ADDENDUM NO. 1 TO PROJECT NO. 43262

CONSTRUCTION WORK, HVAC WORK, PLUMBING WORK, ELECTRICAL WORK

**PROVIDE LONG TERM CARE ADDITION AT G-WING
RENOVATE C AND E WINGS WALSH MEDICAL RMU
WALSH MEDICAL RMU
BUILDING No. 52
MOHAWK CORRECTIONAL FACILITY
6514 STATE RTE. 26, ROME, N.Y.**

September 26, 2011

09-21-11	ADDENDUM-1	
04-19-11	BID DOCUMENTS	
06-10-09	REVISED SUBMISSION	
03-18-09	SUBMISSION	
MARK	DATE	DESCRIPTION
PROJECT NUMBER:	43262-C	
DESIGNED BY:	REID SIMONDS	
DRAWN BY:	N. LENDRUM	
FIELD CHECK:		
APPROVED:		
SHEET TITLE:	G-WING NORTH FIRST FLOOR CEILING PLAN	
DRAWING NUMBER:	A-119

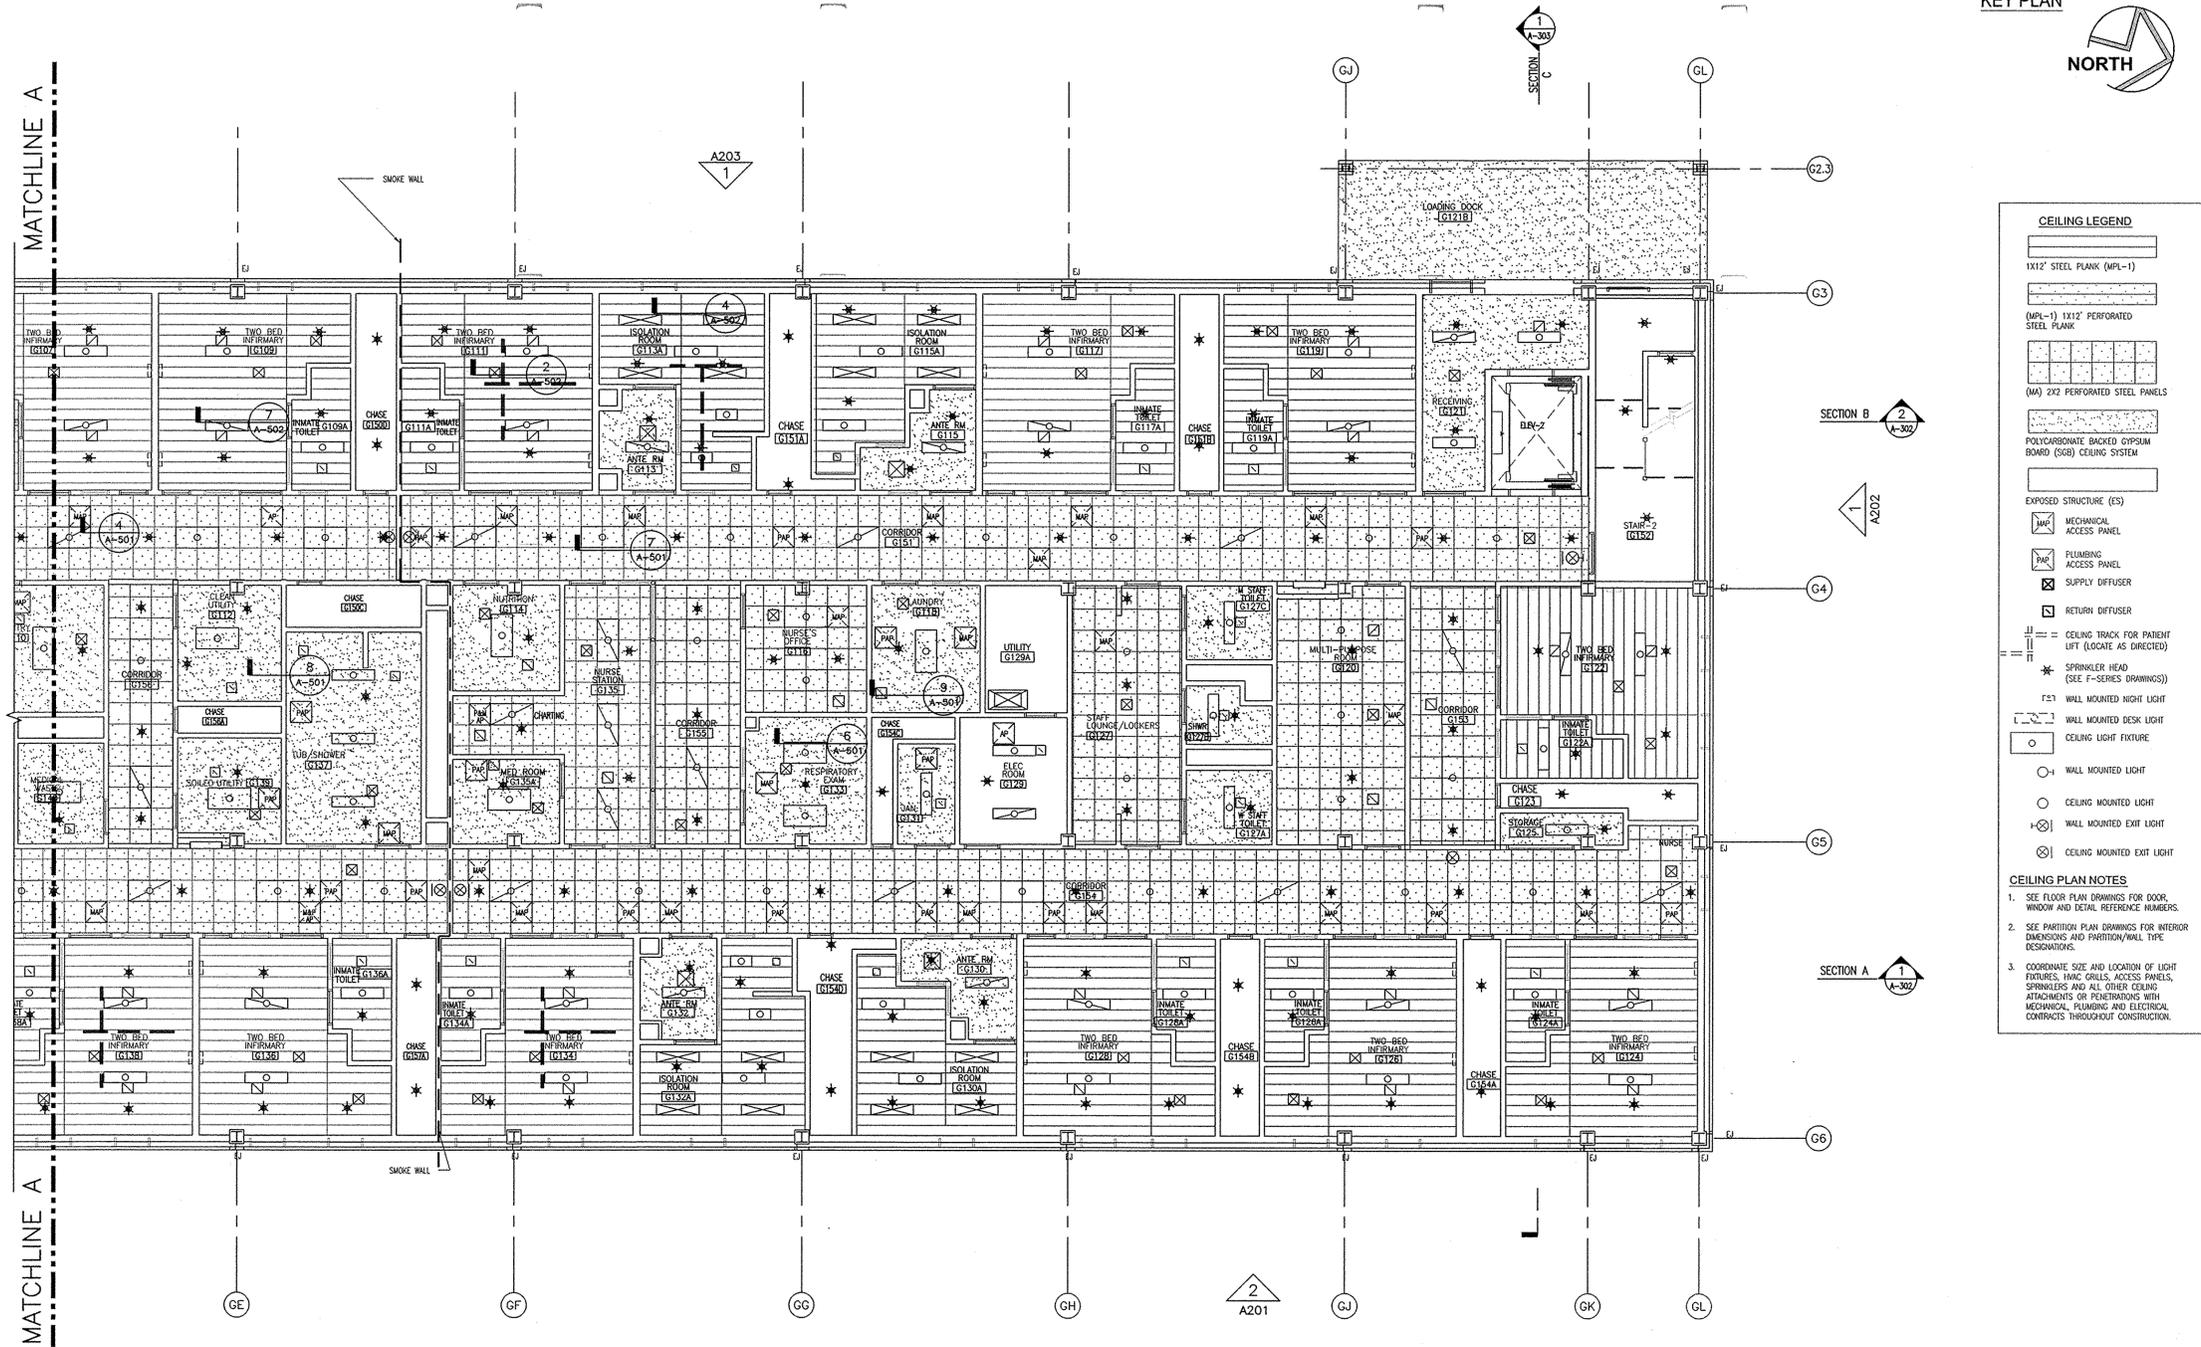
24. REPLACE DRAWING A-119:
 - a. Replace A-119 with revised drawing A-119 titled "G-WING NORTH, FIRST FLOOR, CEILING PLAN, ADDENDUM - 1" which is attached to this Addendum and becomes part of the Contract Documents. (The replacement drawing shows the light fixtures.)

SECURITY FENCE PENETRATION DETAILS

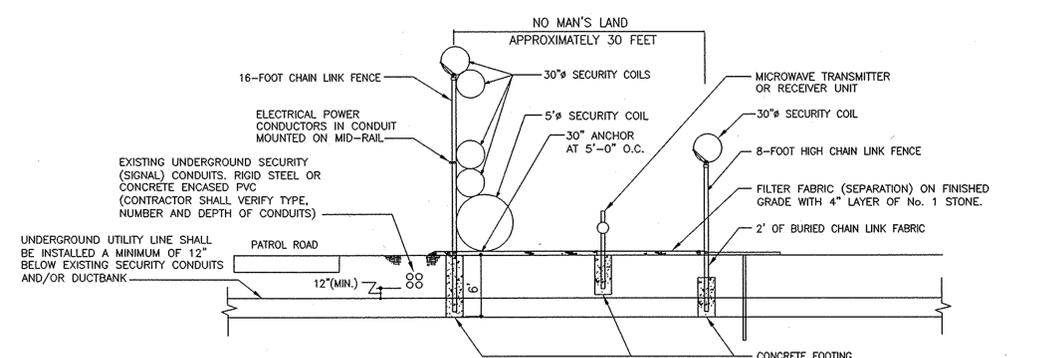
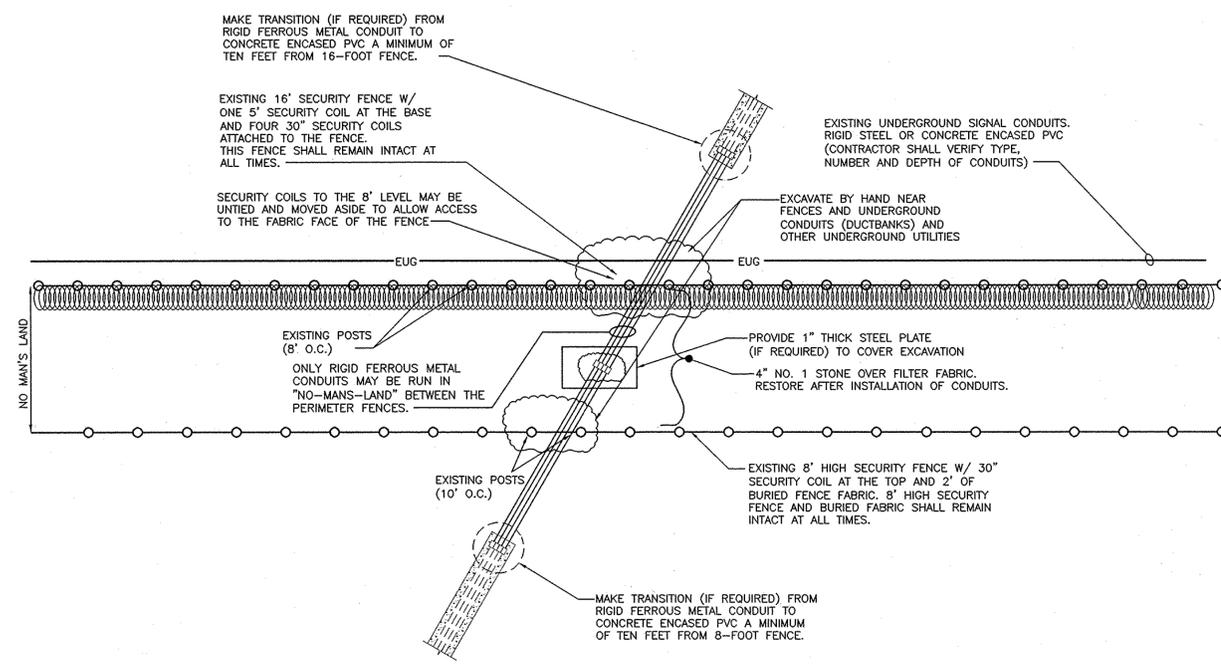
7. DRAWING C-100:
- a. Add the following to "GENERAL SECURITY NOTES":
- "F. AFTER THE INSTALLATION OF THE TEMPORARY FENCE SURROUNDING THE OXYGEN TANK AREA IS COMPLETE AND SO AS TO ALLOW FOR THE INSTALLATION OF THE UNDERGROUND OXYGEN LINE THRU THE PERIMETER FENCES BY THE PLUMBING WORK CONTRACTOR, PERFORM THE FOLLOWING:

1. COORDINATE WORK WITH ELECTRICAL WORK CONTRACTOR, SO THAT ELECTRICAL WORK CONTRACTOR CAN RE-LOCATE WIRING AND CONDUIT RUNNING ON MID-RAIL OF 16-FOOT FENCE.

2. REMOVE A PORTION OF THE 16-FOOT HIGH PERIMETER FENCE (FENCE FABRIC, RAILS, SECURITY COILS, ETC.) WHERE TRENCHING FOR THE OXYGEN LINE IS TO BE PERFORMED BY THE PLUMBING WORK CONTRACTOR.

3. ONCE THE OXYGEN LINE IS INSTALLED, TRENCH IS BACKFILLED AND FILTER FABRIC AND STONE IS INSTALLED, RE-STORE THE 16-FOOT HIGH FENCE TO ITS PRE-CONSTRUCTION CONDITION.

4. COORDINATE WORK WITH ELECTRICAL WORK CONTRACTOR, SO THAT ELECTRICAL WORK CONTRACTOR CAN REMOVE TEMPORARY WIRING AND RE-STORE CONDUIT (AND CONDUCTORS) RUNNING ON MID-RAIL OF 16-FOOT FENCE TO THEIR PRE-CONSTRUCTION CONDITION."

DRAWING NUMBER: E-SEC1

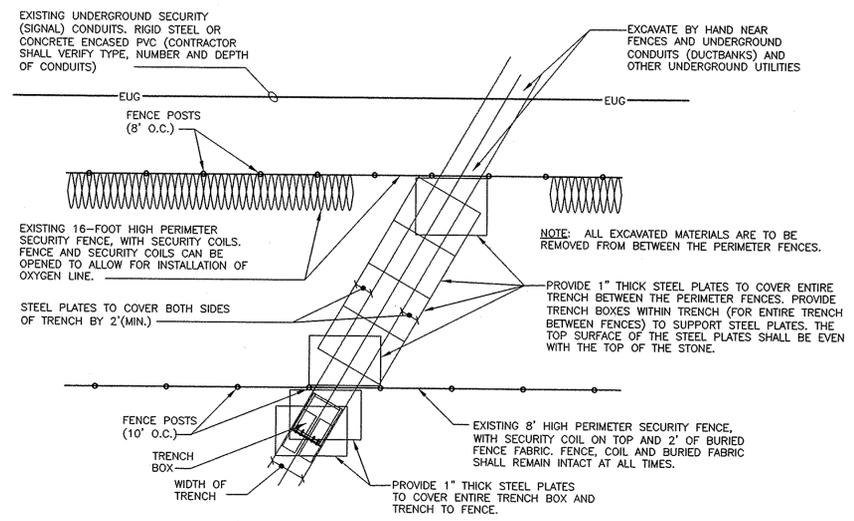
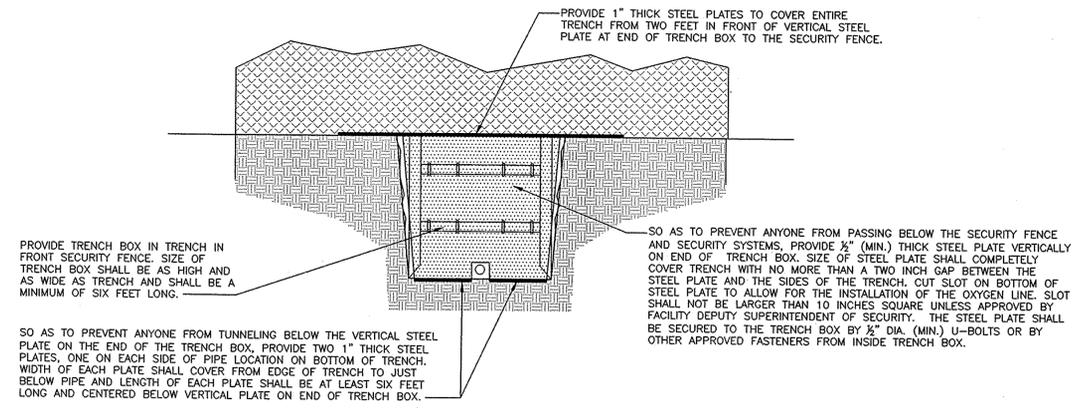
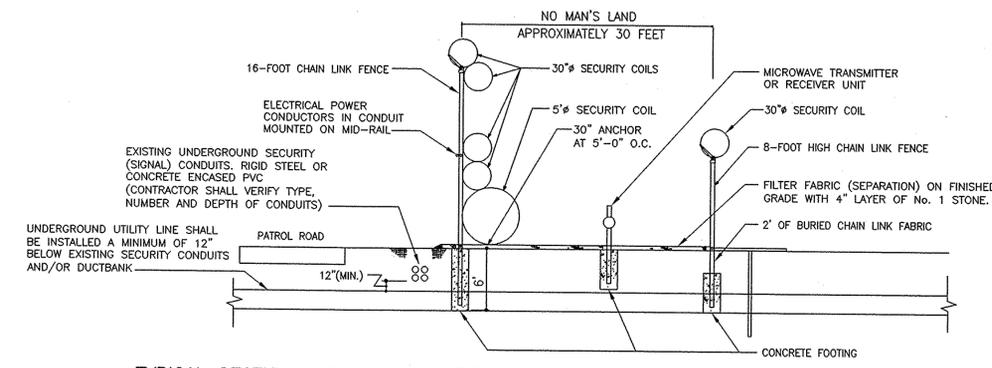
- 1. COORDINATE WORK WITH CONSTRUCTION WORK CONTRACTOR AND PLUMBING WORK CONTRACTOR, SO THAT EXISTING CONDUCTORS AND CONDUIT RUNNING ON MID-RAIL OF 16-FOOT FENCE CAN BE RELOCATED OVER OPENING THRU FENCE. PROVIDE LIQUIDTIGHT FLEXIBLE METAL CONDUIT AND CONDUCTORS AS REQUIRED TO RELOCATE WIRING. NUMBER AND SIZES OF CONDUCTORS SHALL MATCH EXISTING (ASSUME NINE #6 AWG CONDUCTORS, CONTRACTOR SHALL VERIFY). ROUTING AND SIZE OF LIQUIDTIGHT FLEXIBLE METAL CONDUIT SHALL BE AS REQUIRED.

- 2. ONCE THE OXYGEN LINE IS INSTALLED, TRENCH IS BACKFILLED AND FILTER FABRIC AND STONE IS INSTALLED, AND THE 16-FOOT HIGH FENCE IS RE-STORED TO ITS PRE-CONSTRUCTION CONDITION, REMOVE TEMPORARY WIRING AND RE-STORE CONDUIT (AND CONDUCTORS) RUNNING ON MID-RAIL OF 16-FOOT FENCE TO THEIR PRE-CONSTRUCTION CONDITION.

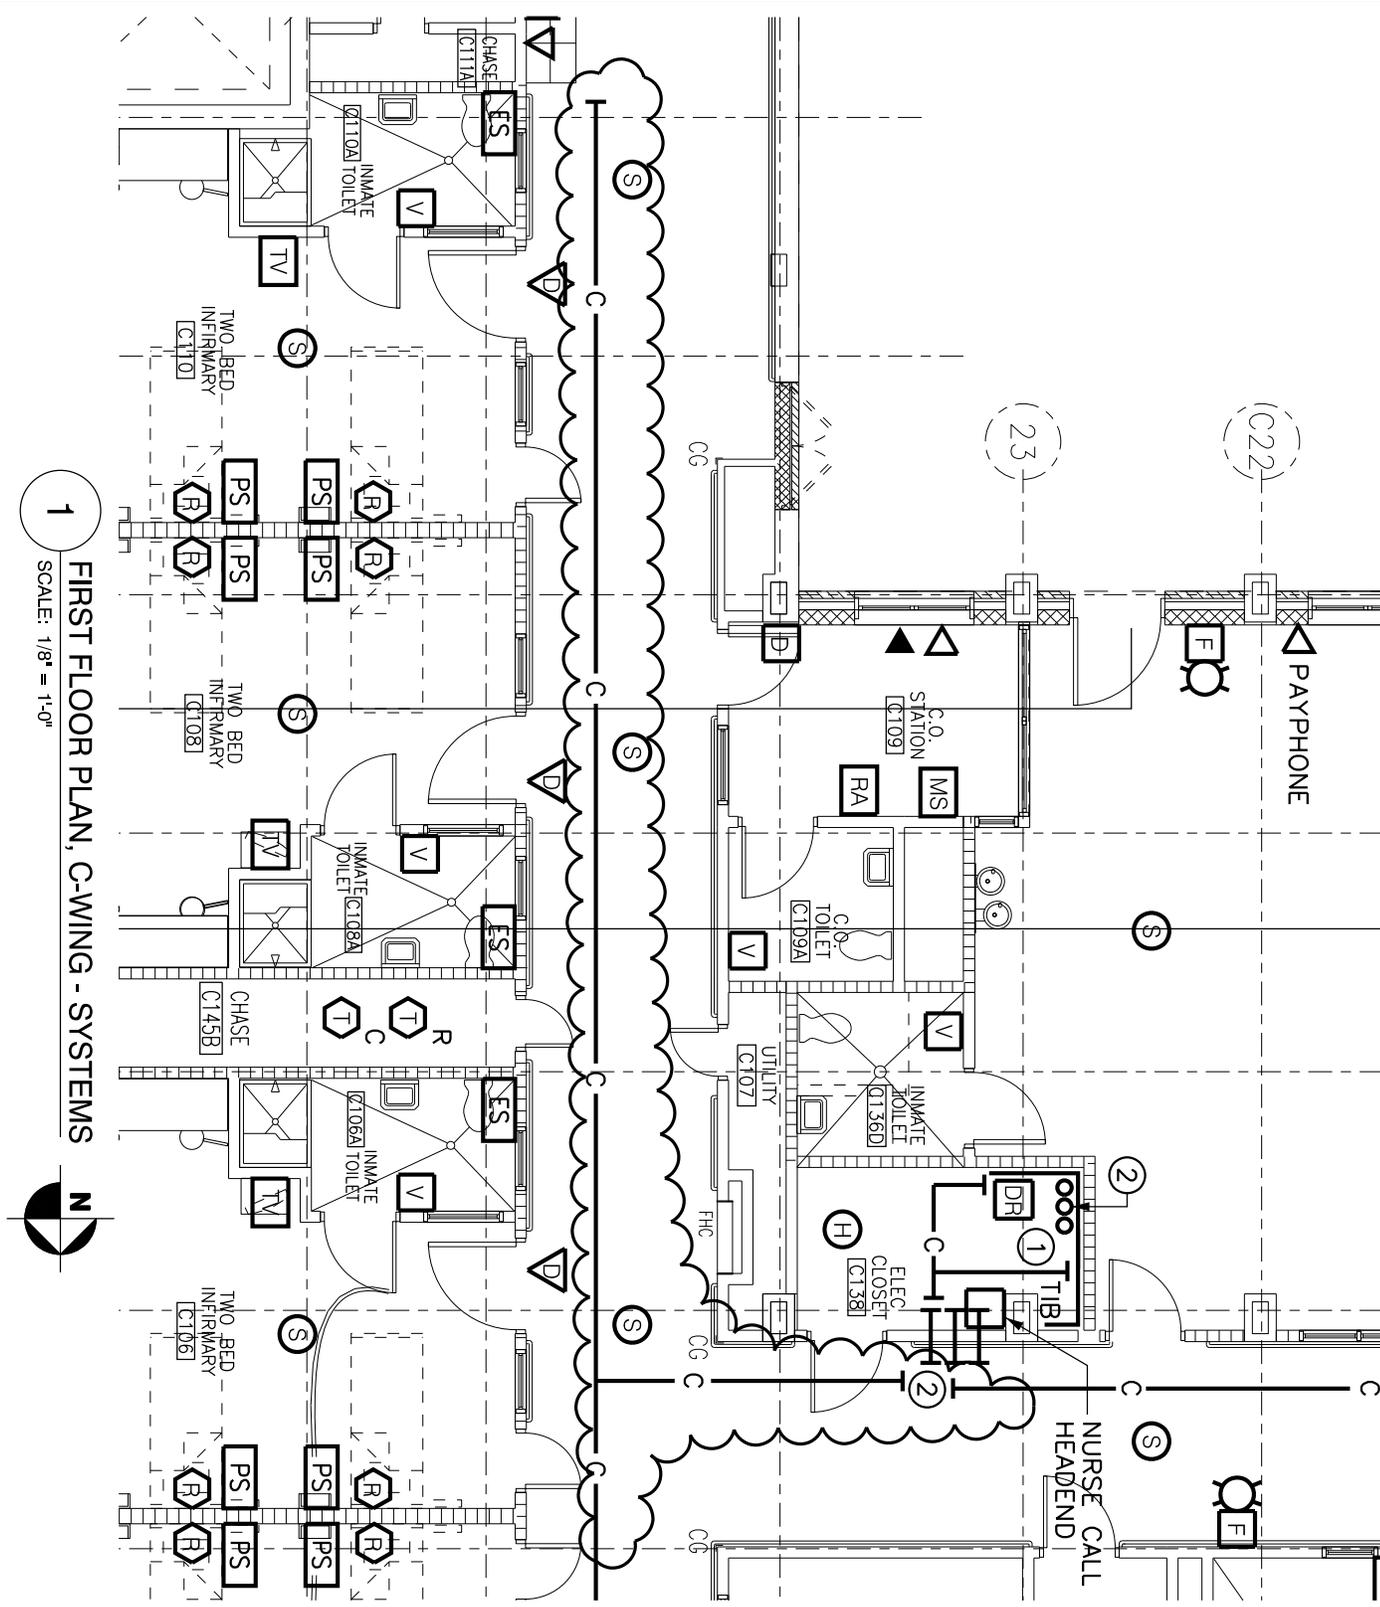
- a. Refer to Detail 1. Revise loading dock lighting. See attached Sketch E-701.
 - b. Refer to Detail 1. Revise note "Mount 25' above finished grade (typical)" to read "Mount exterior fixtures so that center line is at 10'-0" above finished floor. Refer to architectural elevation plans for additional information (typical)."

ADDENDUM #1 REFERENCE DRAWING: E-114

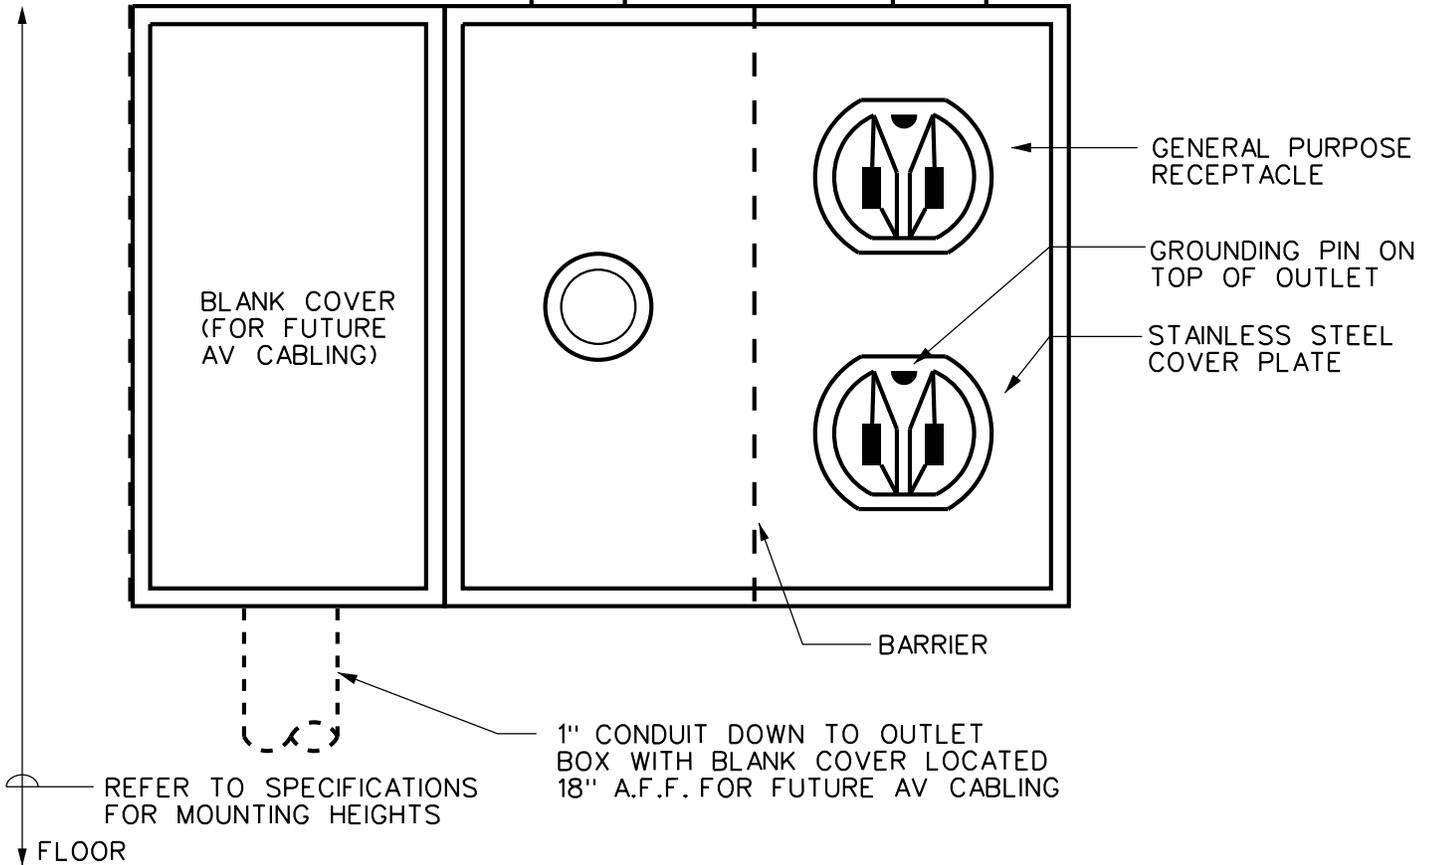
- c. Refer to Detail 1, Corridor C146. Revise exterior fixture HPS1A at exterior door to HPS-1.
35. DRAWING E-114 - FIRST FLOOR PLAN C-WING - SYSTEMS:
 - a. Refer to Detail 1, Corridor C140. Add cable tray, see attached Sketches E-702 and E-703.
